Figure 168–18—Mixing segment and reference points

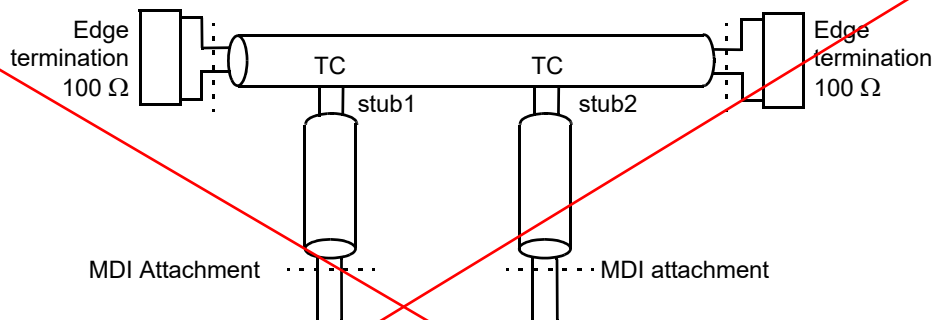
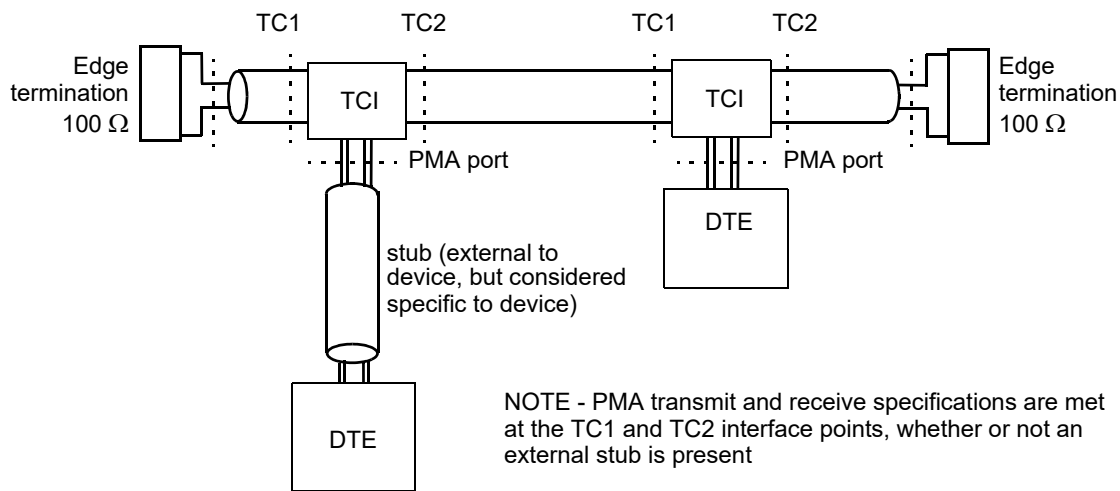
~~Figure 168-18 shows an example mixing segment with reference points. The mixing segment specifications in 168.7 are referenced to these designated points and are to be met without the MDI or other loads attached. The mixing segment specifications are based on a trunk-stub configuration. Other configurations may be possible, provided they meet the electrical parameters in this 168.7. The example configuration assumes that the trunk comprises TBD m of 1.02 mm (18 AWG) 100 Ω cabling and the stubs are 100 Ω balanced pairs of conductors up to 30 cm long. The trunk is terminated at each end into 100 Ω , at a point designated the 'edge termination'. One end of the stub is designated the trunk connection (TC) and the other designated the 'MDI attachment point'.~~

Figure 168–18 shows an example mixing segment with reference points. The mixing segment specifications in 168.7 are referenced to these designated points and are to be met without the MDI or other loads attached. The mixing segment specifications provide for a trunk-stub configuration, extended from the TCI. The electrical parameters in 168.7 include any trunk connection interface (TCI) connecting the left and right sides of the mixing segment, but do not include any external connection such as a stub or service loop from the TCI to the DTE hardware. The example trunk comprises TBD m of 1.02 mm (18 AWG) 100 Ω cabling, with a TCI at each location that a DTE may attach. The TCI is part of the mixing segment, and the requirements of 168.7 are met with TCIs in place with or without attached DTEs as specified for the particular specification. See 168.8 for further definition and description of the TCI. The trunk is terminated at each end into 100 Ω, at the point designated the ‘edge termination’.

Figure 168–19—TCI ports and connections

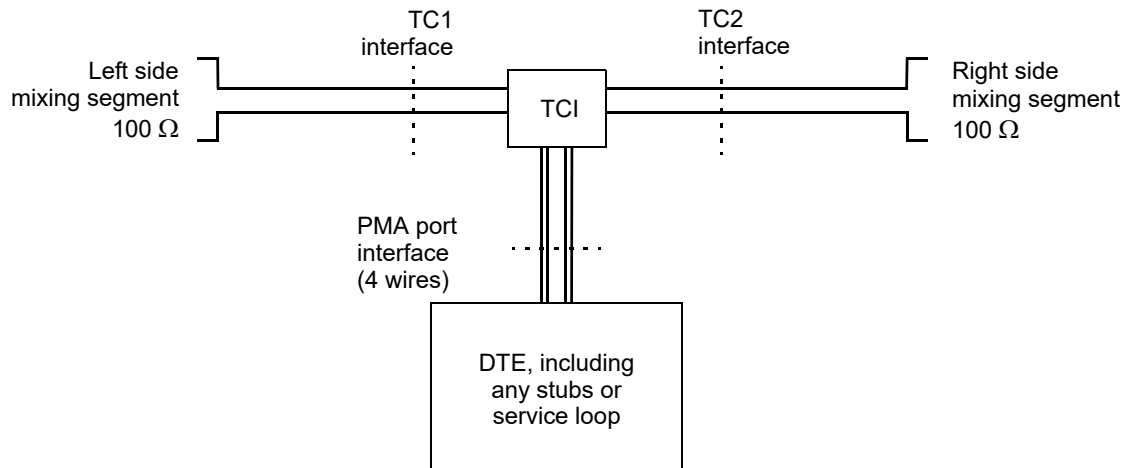
The interface of the Clause 168 PHY to the mixing segment is called the Trunk Connection Interface (TCI). While technically it aligns with the definition of an MDI in 1.4.395, the fact that the TCI has two ports to the medium and plays a role in mixing segment specifications by connecting the left and right sides of the linear mixing segment mandates it has a unique role beyond what is normally considered in an MDI.

Each TCI has two interfaces and a four-wire interface connecting to the DTE (and any associated stub or service loop) at the TCI's PMA port. as shown in Figure 168–19.
